ADL/AM/6854/20A

**Re: 3/2025/0794 - PRIOR NOTIFICATION FOR PROPOSED CHANGE OF USE OF AN AGRICULTURAL BUILDING TO OFFICE USE INCLUDING ANCILLARY PARKING AND OPEN SPACE UNDER SCHEDULE 2 PART 3, CLASS R OF THE GDPO - OLD DAIRY FARM, CHIPPING ROAD, CHAIGLEY, BB7 3LS.**

This Letter is specifically provided in response to the Lancashire County Council (LCC) highway consultation response dated 16<sup>th</sup> October 2025. The highway consultation response summary is set out below:

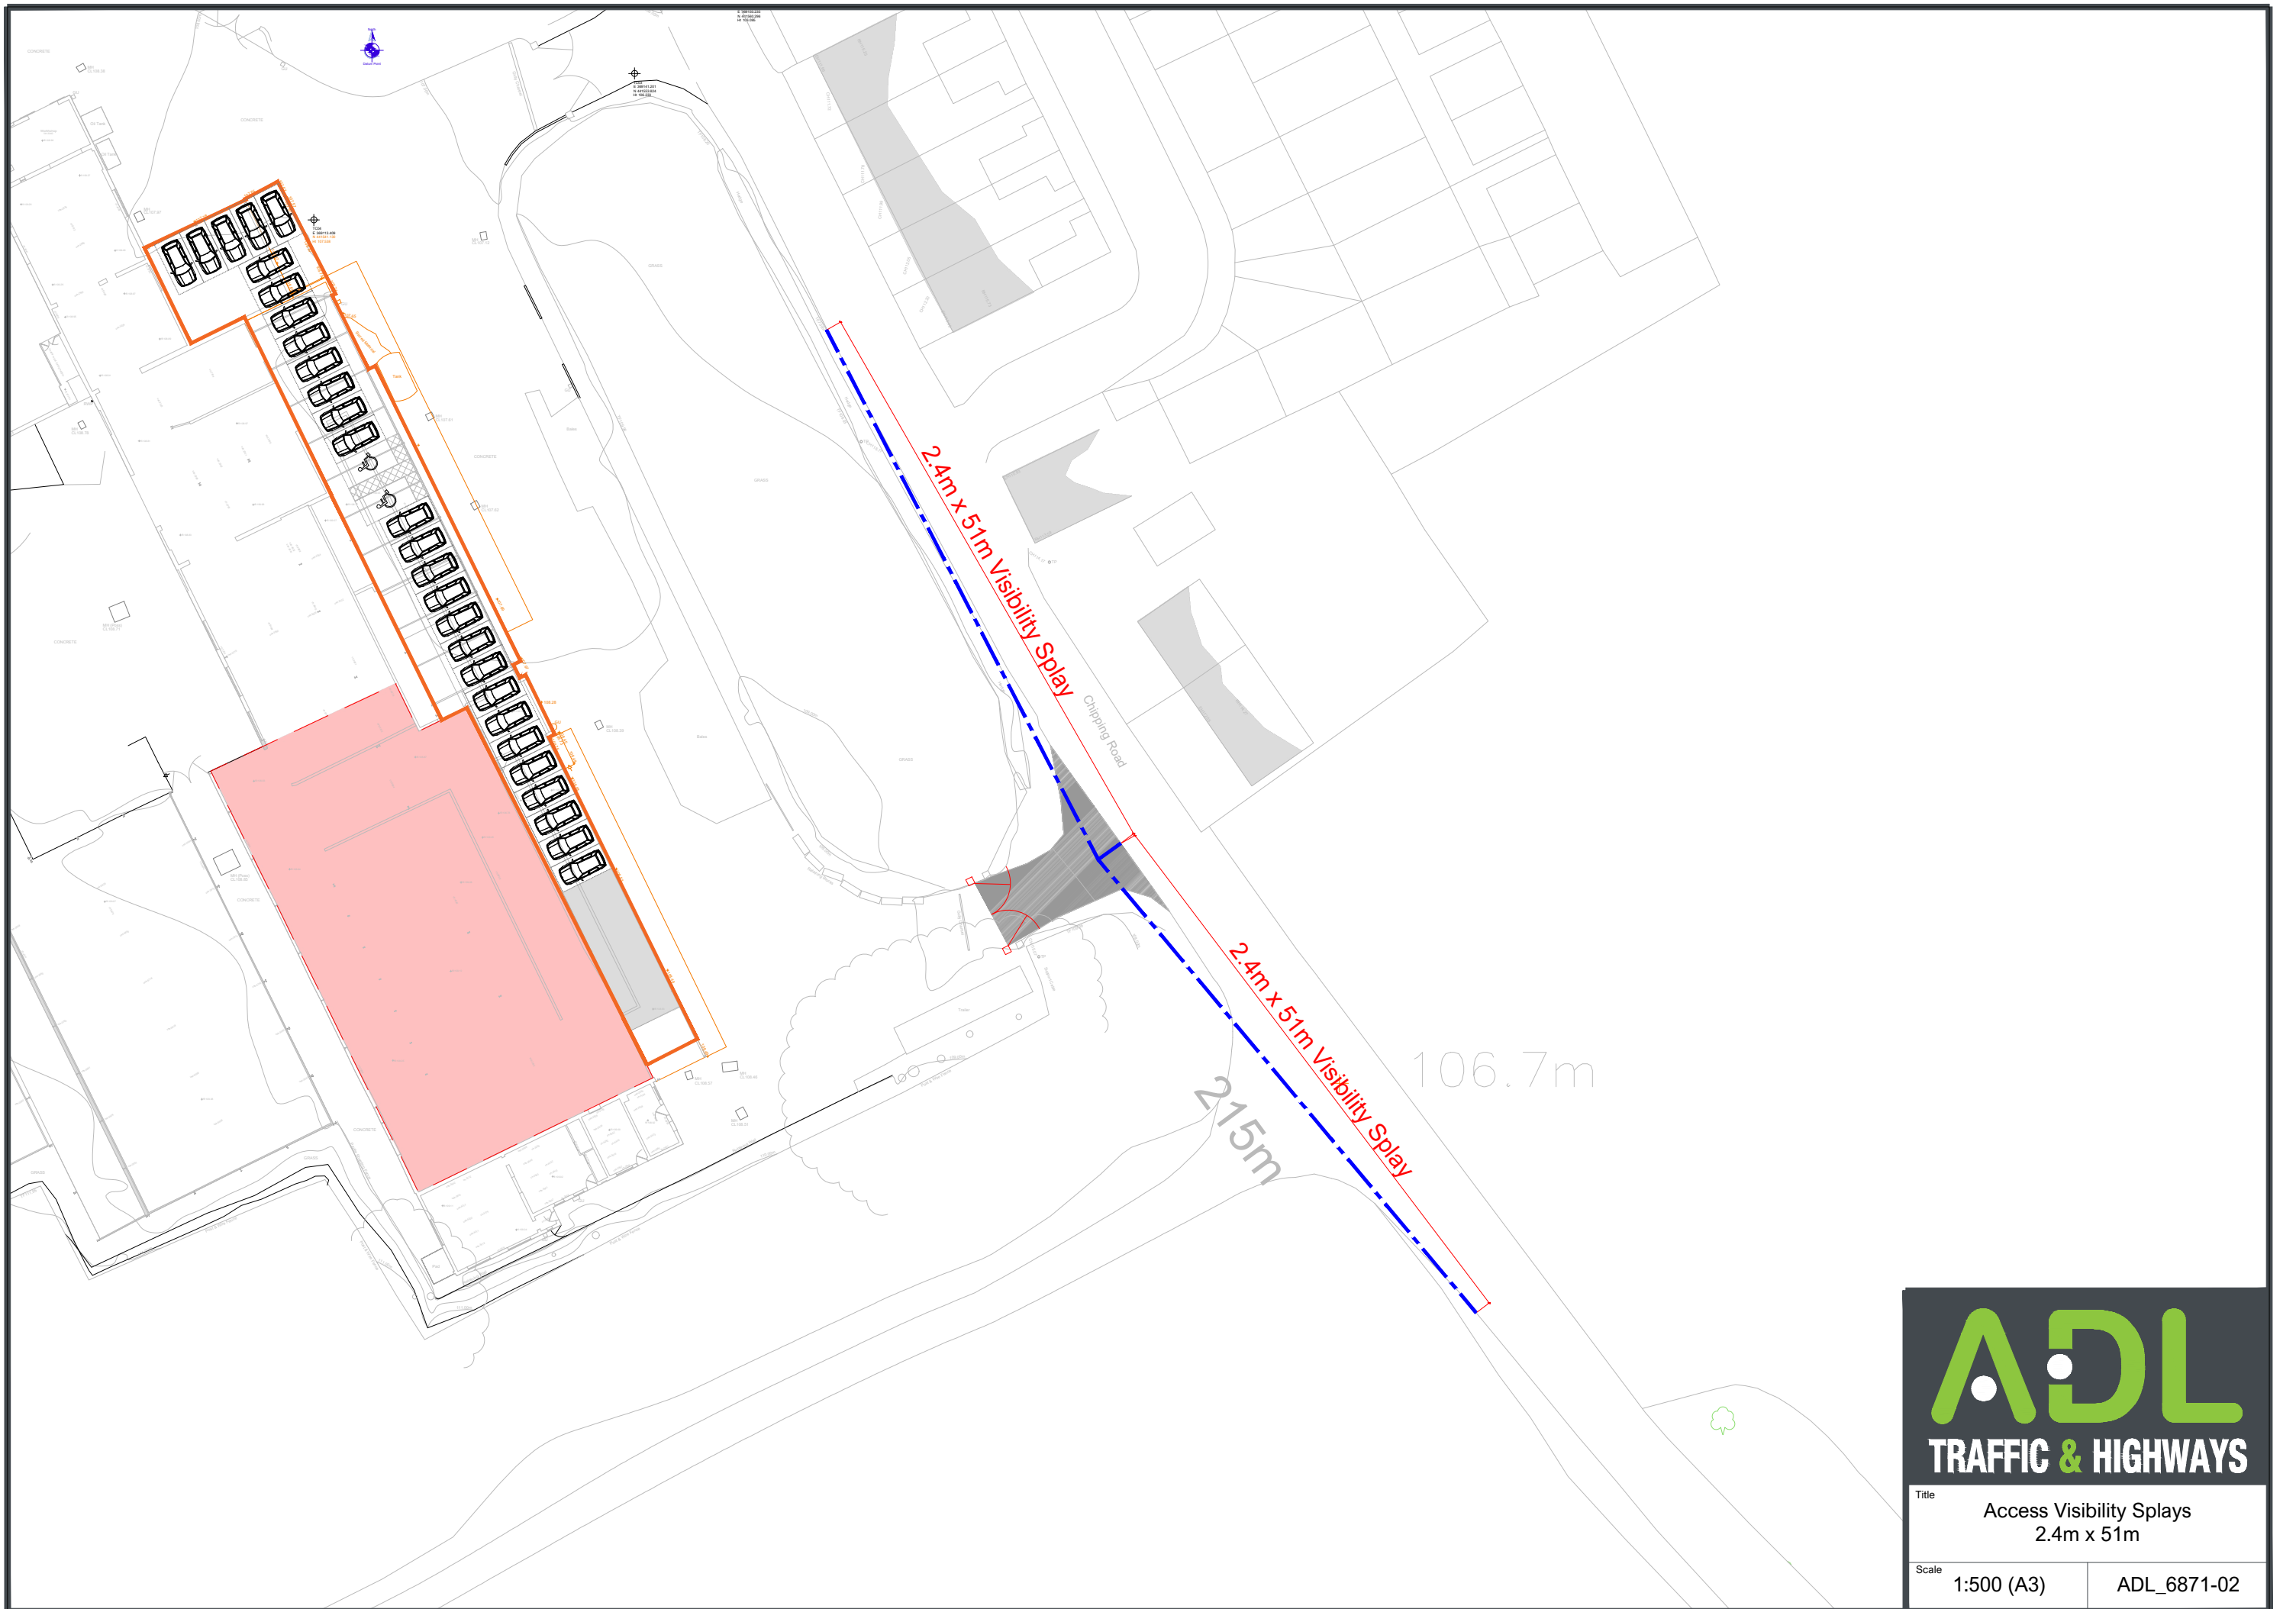
As noted in the highway consultation response *“The applicant has suggested that the proposal will have 15 vehicle movements a day.”* Given the location of the site, it is likely that the office use would attract a fairly niche business, and traffic generation would not be significant.

To provide an indication of the possible quantum of vehicles associated with an office proposal comprising 889sqm, ADL can review TRICS for comparable sites. Upon review, however, it is noted that there are no directly comparable (rural) sites. To assess a worst case scenario a TRICS profile was created for office sites in edge of town or suburban locations, for office units up to 2,500sqm.

As shown above, the office use could theoretically generated up to 17 vehicles two-way in a peak hour, and up to 121 two-way vehicles daily. This level of traffic would not result in a significant impact on the local highway network. The parking accumulation could be up to 27 parked cars, which would be facilitated within the proposed car park which indicates 30 formal spaces, and further space for any overspill within the site.
